# UNITED STATES PATENT AND TRADEMARK OFFICE

APPLICATION NO.	FILING DATE	FIRST NAMED INVENTOR	ATTORNEY DOCKET NO.	CONFIRMATION NO.
10/528,920	01/09/2006	Michael R Smith	0837RF-H547-US	9046
38441 7590 03/29/2011 LAW OFFICES OF JAMES E. WALTON, PLLC 1169 N. BURLESON BLVD. SUITE 107-328 BURLESON, TX 76028				
EXAMINER				
BURCH, MELODY M				
ART UNIT		PAPER NUMBER		
3657				
NOTIFICATION DATE		DELIVERY MODE		
03/29/2011		ELECTRONIC

**Office Action Summary****Application No.**

**DETAILED ACTION**

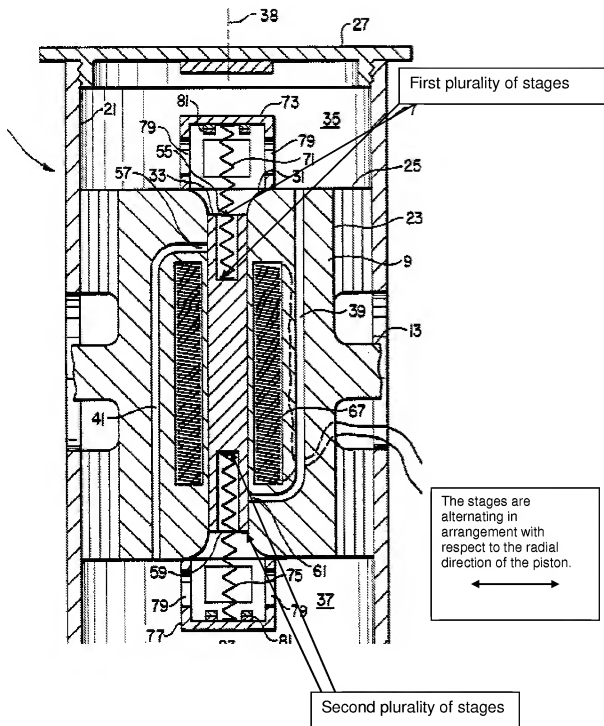
Re: claim 21. McKeown et al. show in figure 4 a vibration isolator comprising a housing 7,27,29, a piston 33 resiliently disposed within housing, the piston being adapted for connection to a first body, a first fluid chamber 35 and a second fluid chamber 37 each being defined by the housing and the first piston, a first tuning port or top of 31, 41 in fluid communication with both the first fluid chamber and the second fluid chamber; and a tuning fluid disposed within the first fluid chamber, the second fluid

chamber, the first tuning port, and the second tuning port; wherein the first tuning port allows isolation of vibration at a first selected frequency, the isolation of vibration at the first selected frequency being a result of displacement of the tuning fluid in the first tuning port, the displacement being a result of movement of the piston, wherein the second tuning port allows isolation of vibration at a second selected frequency, the isolation of vibration at the second selected frequency being a result of displacement of the tuning fluid in the second tuning port, the displacement being a result of movement of the piston.

Re: claim 23. McKeown et al., as modified, teach in figure 4 of McKeown et al. a spring-mass system 75, 77 associated with the second tuning port, the spring-mass system being configured to provide an additional degree of freedom.

Re: claim 24. McKeown et al., as modified, teach in figure 4 of McKeown et al. additional tuning ports top 79 and bottom 79 wherein each additional tuning port allows isolation of vibration at a corresponding additional selected frequency.

Re: claims 25 and 27. McKeown et al. show in figure 4 a vibration isolator comprising: a first housing 7, 27, 29 a first piston 9 resiliently disposed within the first housing, the first being adapted for connection to a first body, a tuning port 31,41 in fluid communication with both a first fluid chamber 35 and a second fluid chamber 37, the first fluid chamber and the second fluid chamber each being defined by the first housing and the first piston as shown, a second housing 73, a second multi-stage piston 33 resiliently disposed within the second housing, the second piston being configured to define a first plurality of stages in fluid communication with the first fluid chamber and a second plurality of stages in fluid communication with the second fluid chamber; at least one actuator 67 coupled to the second multistage piston 33 for selectively transferring forces to the second multistage piston; a tuning fluid disposed within the first fluid chamber, the second fluid chamber, the tuning port, the first plurality of stages, and the second plurality of stages.

Re: claim 28. McKeown et al. show in figure 4 a first housing 73, a first multistage piston 33 resiliently disposed within the first housing, the first multistage piston being configured to define a first plurality of stages in fluid communication with a first fluid chamber 35, and a second plurality of stages in fluid communication with a second fluid chamber 37; a second housing 7, 27, 29; a second piston 9 resiliently disposed within the second housing, the second piston being adapted for connection to a first body; at least one actuator 67 coupled to the first multistage piston 33 for

With regards to claims 21, 23, and 24, Applicant argues that the McKeown reference, as modified, fails to read on the limitations added to amended claim 21. Examiner disagrees and notes that the movement of the piston within the first tuning port or top portion of 31 and 41 and the second tuning port or bottom portion of 31 and 39 of McKeown, as modified, results in the isolation of harmonic vibrations at various frequencies.

With respect to claims 25 and 27 Applicant argues that McKeown does not anticipate the claims because McKeown does not have a second housing. Examiner disagrees and notes that element 73 is a second housing which houses the second piston 33, particularly in its extended position when it contacts buffers 81. Applicant

also argues that McKeown fails to show or suggest the limitation of the at least one actuator coupled to the second piston explaining that element 67 is not coupled to element 33. Examiner disagrees and notes that, as broadly recited, the at least one actuator 67 is magnetically coupled to piston 33. This response also applies to the similar arguments presented with respect to claim 28.
